INITIAL FIRE SAFETY INSPECTION REPORT

Fatullah Apparels

RSC ID: 24155

Date: 31-May-2021

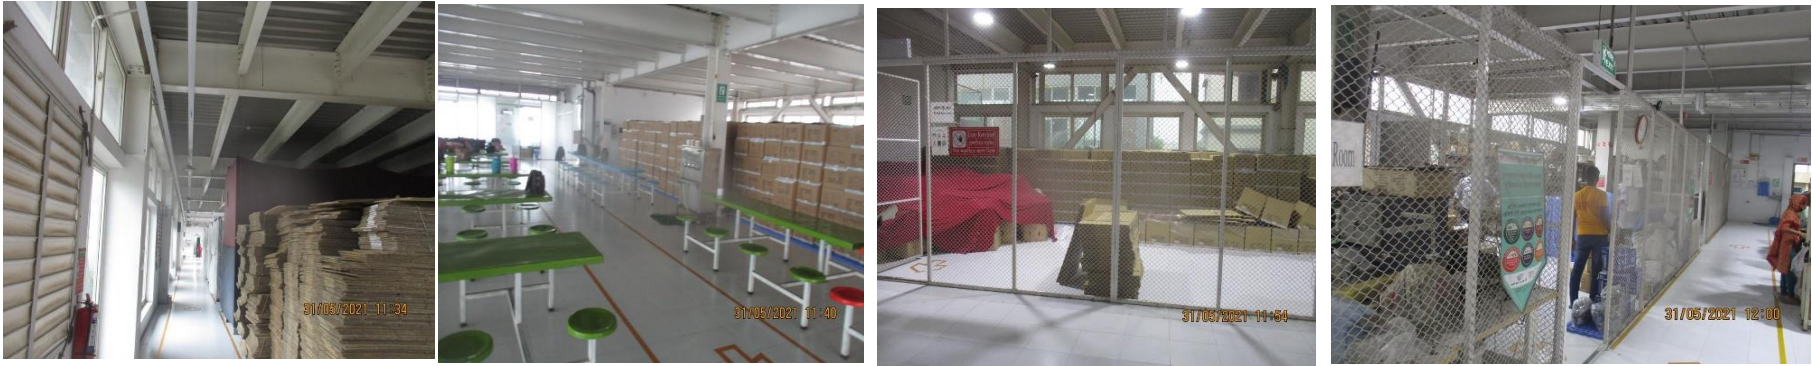
SI No.	Category	Findings	Required Action	Remediation Time Frame
F-16	Structural Fire Protection	Building 03 Since the structure is steel-composite type and all the RCC panels are resting on the steel columns and the guarders. Hence, each floor of the building is not separated by a fire resistive rated construction barriers.	Construction must be of type 1 or type 2 (See BNBC 2006 Part 3 Section 3.2.4, page 10356). For type 2 construction, the maximum permissible height of the building shall be 4 storeys or 14 meters. (See BNBC 2006 Part 3, Table 3.1.9, page 10319). Provide/ensure required fire rating on the structural elements by following Section 4.4 and Table 4.4.1 of the Accord Standard or Table 3.3.1 and Table 4.1.1 from BNBC. Consult a qualified fire protection engineer to design the rated construction barriers.	Design within 6 months, Install within 6 months
